WALMART SITE PLAN 10-42A

Public Hearing at the request of Walmart Stores East LP, Inc. for a recommendation to City Council regarding the Special Land Use Permit, Preliminary Site Plan and Stormwater Management Plan. The subject property is located in Section 14, at the northwest corner of Eleven Mile Road and Town Center Drive, in the TC, Town Center District. The subject property is approximately 12.8 acres and the applicant is proposing to demolish portions of the Novi Town Center and construct an approximately 149,000 square foot Walmart store to include an open air area for the sale of plant material and garden supplies.

PLANNING REVIEW

**SUBJECT: Wal-Mart Supercenter Store #5893-00, SP#10-42A, Traffic Review
of Revised Preliminary Site Plan and Traffic Impact Study**

Figure 1. Unsignalized Access Routes from Grand River

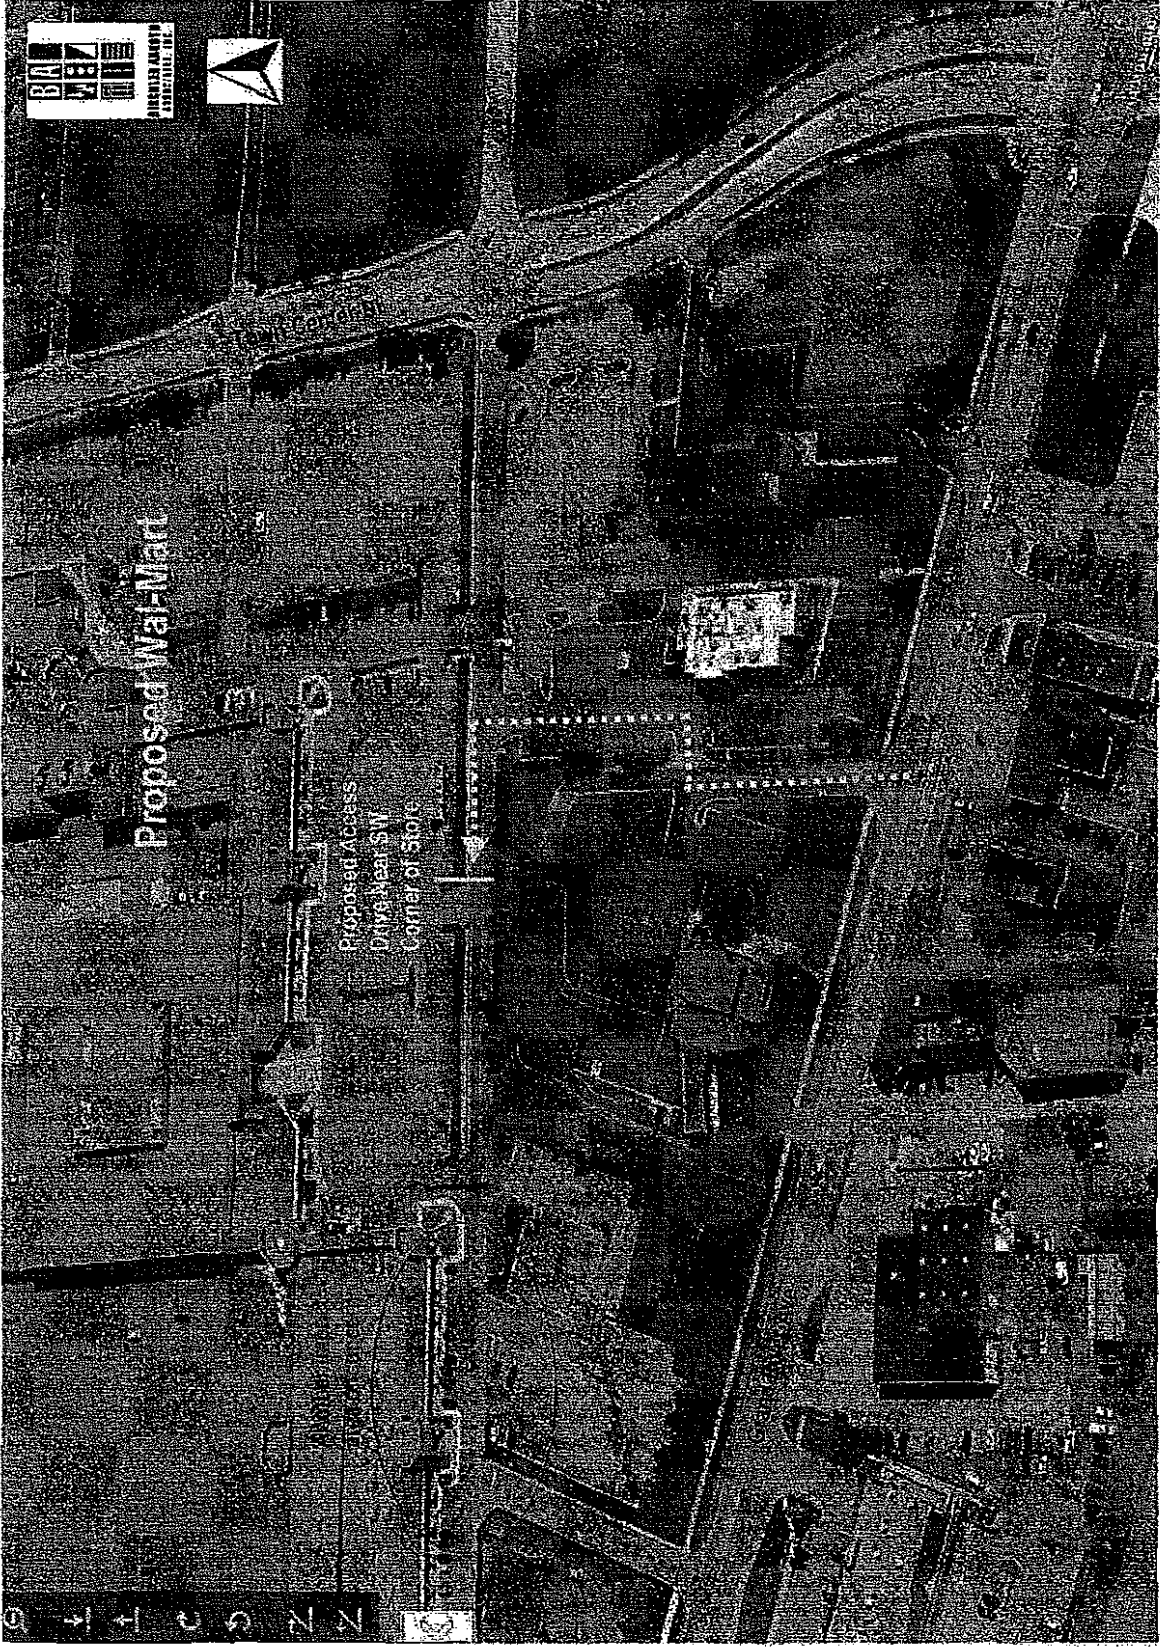
- e. Traffic Assignments – The application of the trip distribution percentages to the trip generation subtotals in the trip generation table was presumably done correctly. It should be noted that as many as seven vehicles per hour were observed cutting through the restaurant site from Grand River to 11 Mile Road (Figure 1, attached) – without a significant existing traffic generator located next to the latter – but the study chose not to assume any such cut-through traffic once the Wal-Mart is built nearby.

Figure 2. Birchler Arroyo Pre-Application Conceptual Design for Portion of Site Near Southwest Corner of Proposed Wal-Mart Store

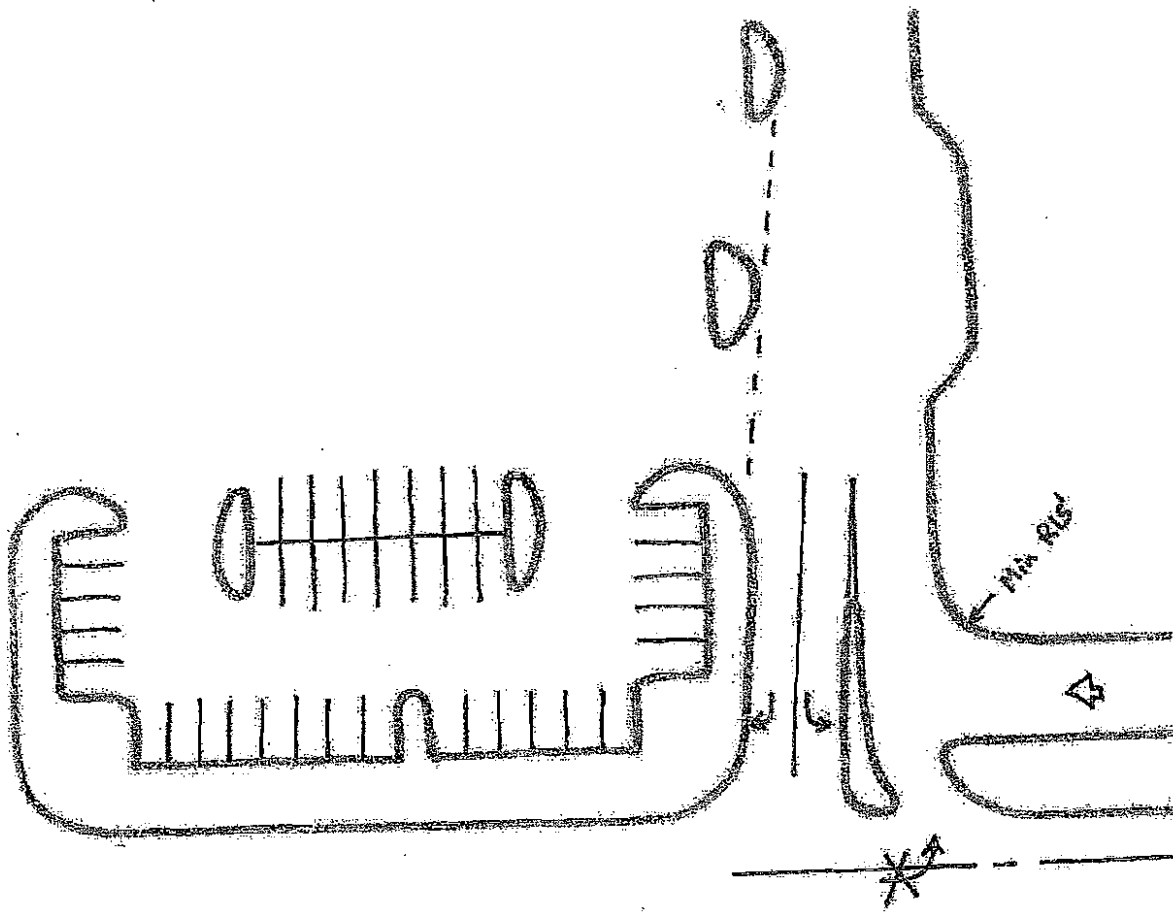
7. The pre-application site plan showed the proposed access drive near the southwest corner of the Wal-Mart store as a right-in/right-out driveway, with a very short throat (the first parking aisle north of 11 Mile would have been directly accessible). We saw no need for prohibiting exiting left turns here if the throat is lengthened as now proposed; however, entering left turns still appeared appropriate given the lack of a left-turn lane on this section of 11 Mile. Our proposed redesign of this area of the site is illustrated in Figure 2 (attached).
